MARK	DATE	DESCRIPTIONS	BY	CH'D	CCO#
0	03/08/10	MEP INTEGRATION	JE	SYC	110

CONTRACT CHANGE ORDER NO._____
SHEET _____ OF _____

DETAILS
SCADA REMOTE TERMINAL UNIT SYSTEM TELEPHONE CABLE BLOCK DIAGRAM EASTBOUND
NO SCALE

E-963

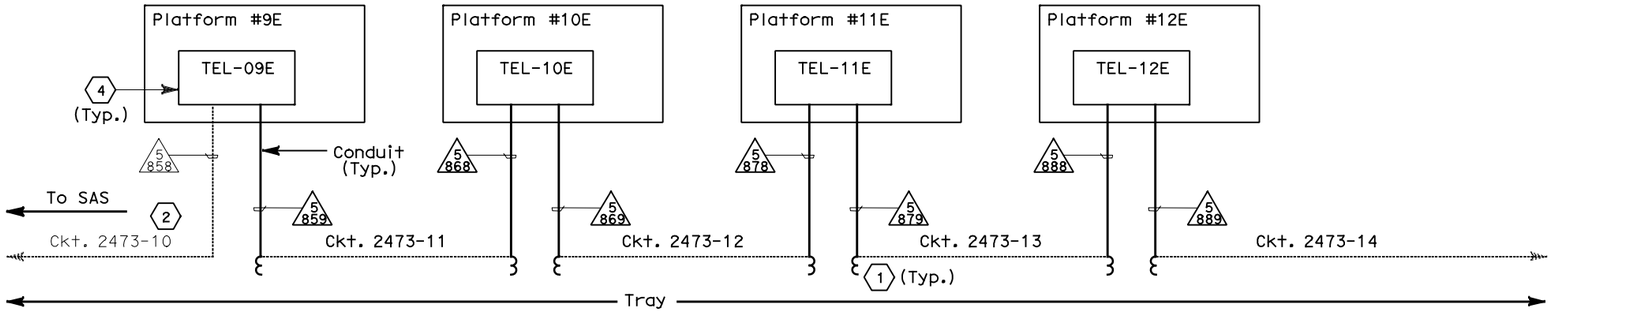
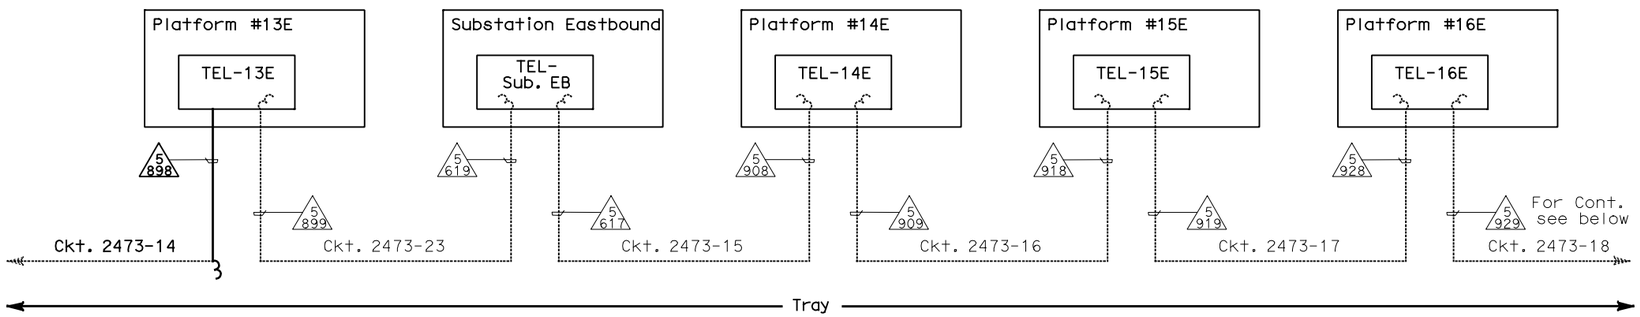
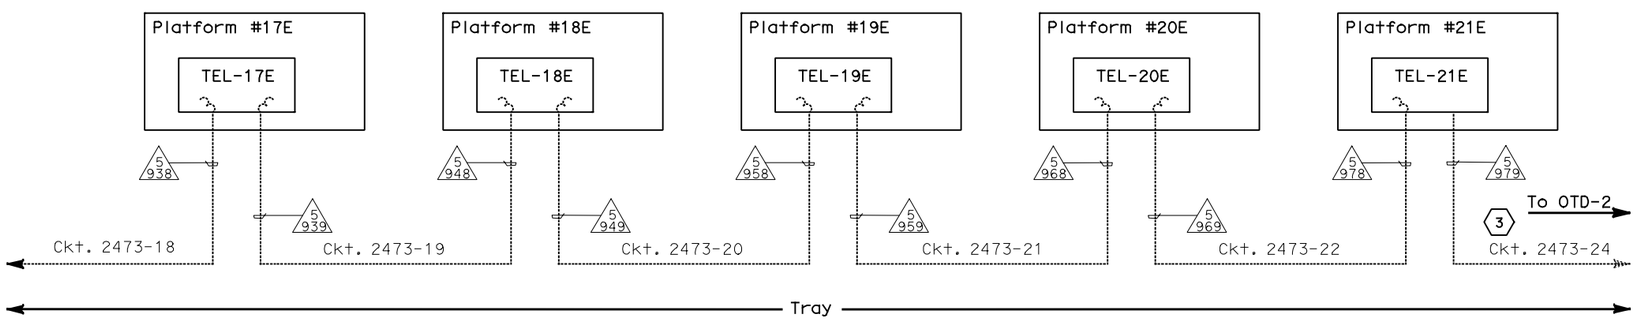
1. All circuits (50 pair #18) shown on this drawing have been installed in the TOS/COM trays spanning the entire Skyway. In the girder at the following platforms the circuits have been coiled in the trays. Contractor shall pull the 50 pair #18 Telephone Cables from the trays into the Telephone Terminal Boxes as follows:

At platform 09E: Pull ckt #2473-10 in conduit # 5858 to TEL-09E.
   At platform 09E: Pull ckt #2473-11 in conduit # 5859 to TEL-09E.
   At platform 10E: Pull ckt #2473-11 in conduit # 5868 to TEL-10E.
   At platform 10E: Pull ckt #2473-12 in conduit # 5869 to TEL-10E.
   At platform 11E: Pull ckt #2473-12 in conduit # 5878 to TEL-11E.
   At platform 11E: Pull ckt #2473-13 in conduit # 5879 to TEL-11E.
   At platform 12E: Pull ckt #2473-13 in conduit # 5888 to TEL-12E.
   At platform 12E: Pull ckt #2473-14 in conduit # 5889 to TEL-12E.
   At platform 13E: Pull ckt #2473-14 in conduit # 5898 to TEL-13E.

(2) The SAS Contractor is responsible for pulling and terminating Ckt. #2473-10.

(3) The OTD-2 contractor is responsible for pulling and terminating Ckt. #2473-24.

(4) Contractor shall terminate all 50 pair #18 cables in the Telephone Terminal Boxes, unless otherwise noted.
